UNITED STATES PATENT AND TRADEMARK OFFICE

APPLICATION NO.	FILING DATE	FIRST NAMED INVENTOR	ATTORNEY DOCKET NO.	CONFIRMATION NO.
10/815,854	04/02/2004	Ronald Alexander Young	3011-1005	9888

Office Action Summary	Application No. 10/815,854	Applicant(s) YOUNG, RONALD ALEXANDER	
	Examiner Shay L. Balsis	Art Unit 1744

DETAILED ACTION

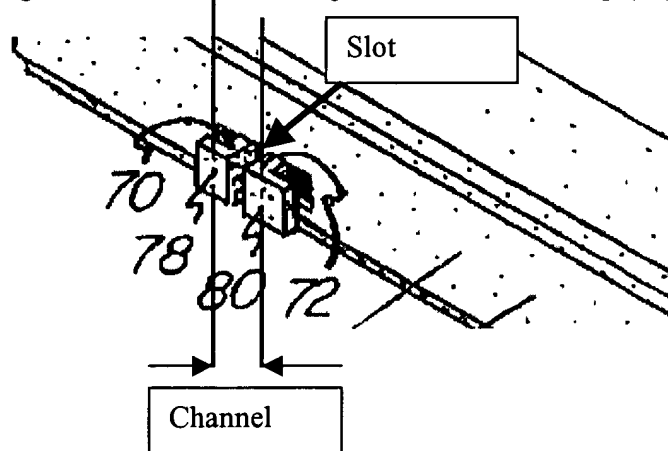
With regards to claim 11, the retaining mechanism includes a channel element (not labeled but located between elements 78 and 52, 80 and 52 in figure 2) by which the cleaning implement is push-fit engageable with the holder (see figure below).

With regards to claim 13, the retaining mechanism further includes a slot (not labeled but located between elements 78 and 80 on figure 2) (see figure below).
